### APPEAL SUMMARY

<b>Appeal ID:</b> 16166	<b>Project Address:</b> 7136 N Vancouver Ave
<b>Hearing Date:</b> 11/22/17	<b>Appellant Name:</b> Tom Jaleski
<b>Case No.:</b> B-016	<b>Appellant Phone:</b> 5034885651
<b>Appeal Type:</b> Building	<b>Plans Examiner/Inspector:</b> Tara Carlson
<b>Project Type:</b> residential	<b>Stories:</b> 3 <b>Occupancy:</b> Townhouses <b>Construction Type:</b> V-B
<b>Building/Business Name:</b>	<b>Fire Sprinklers:</b> No
<b>Appeal Involves:</b> Erection of a new structure	<b>LUR or Permit Application No.:</b> 17-237876-CO
<b>Plan Submitted Option:</b> pdf [File 1]	<b>Proposed use:</b> Townhouses

#### Appeal item 1

**Measurement of fire separation distance where wall openings are not perpendicular to the common property line: Granted as proposed with one hour exterior walls rated for exposure to fire from the inside and non combustibile siding.**

**A2.2**

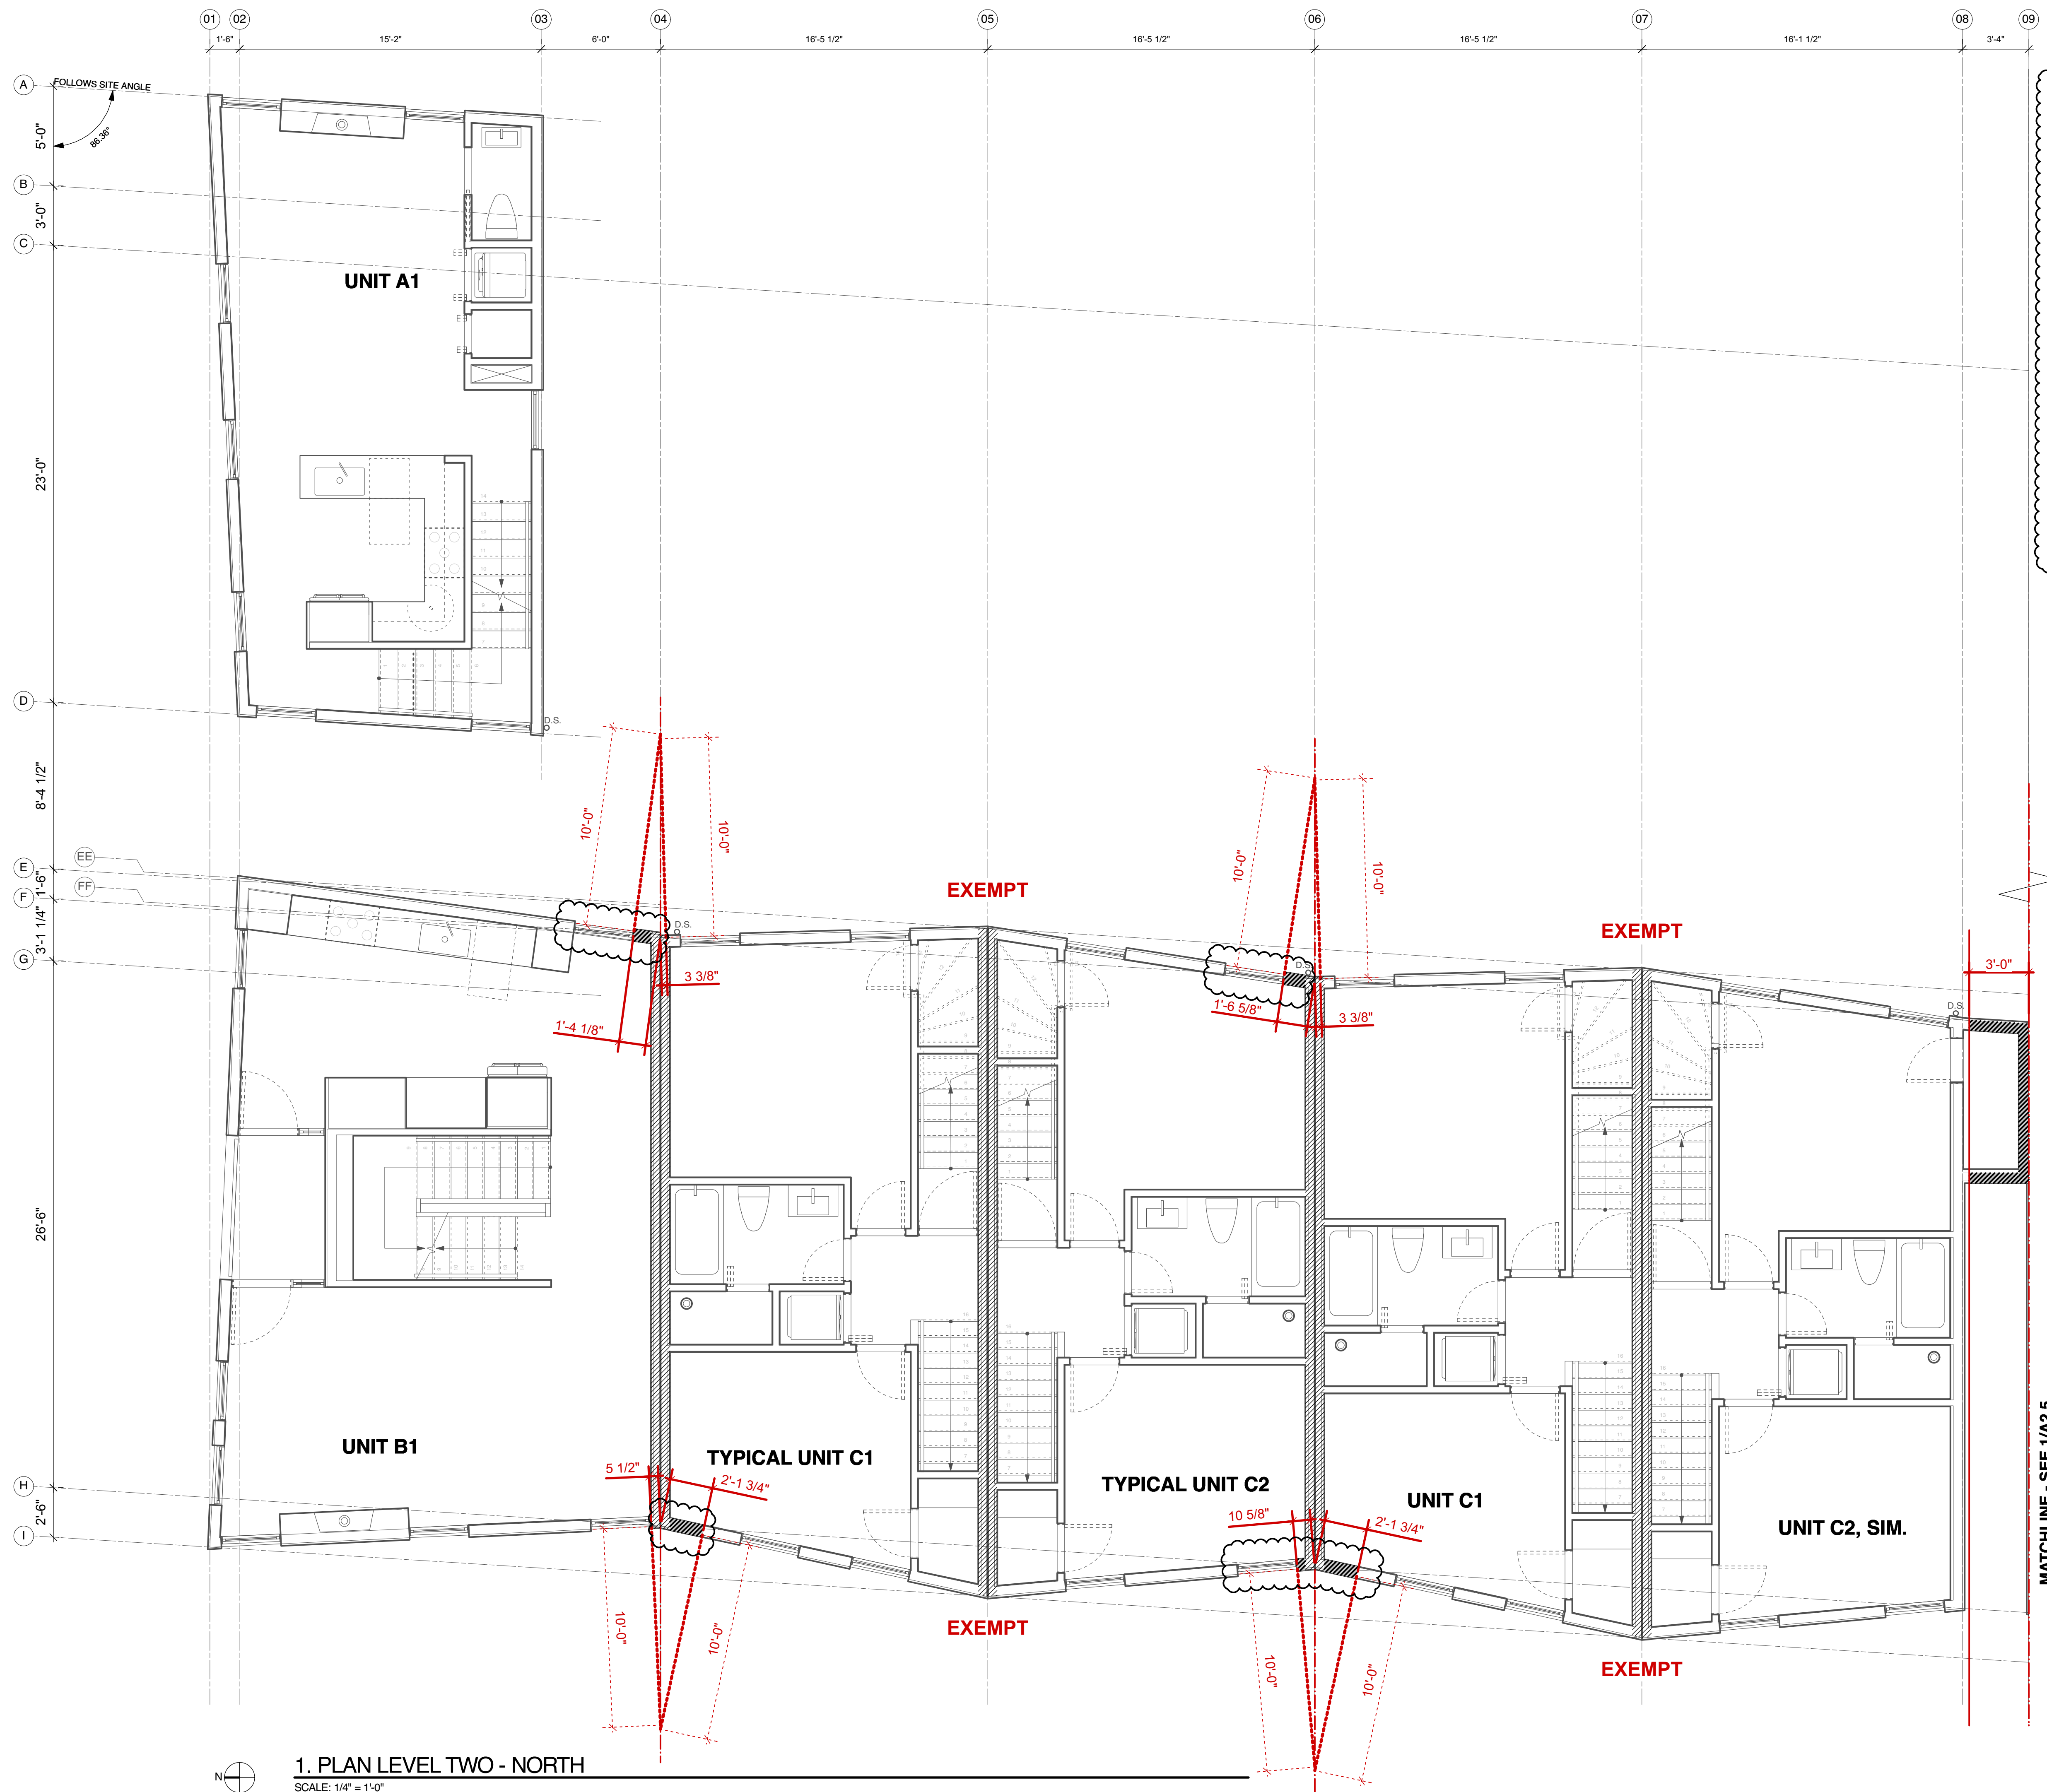
**Proposed Design** The proposed design for lots 2, 3, 4, 5, 7, 8, 9, 10, and 12 of the Origami Townhouses where windows on the exterior walls are less than 3 feet from the common property line and the walls are less than perpendicular to the common property line are as follows:  
The fixed windows will have a fire separation distance of at least 10 feet to the common property line, exceeding the requirement of Table R302.1.  
The walls within 3 feet on either side of the common property line will have a 1 hour rated assembly with non-combustible siding.
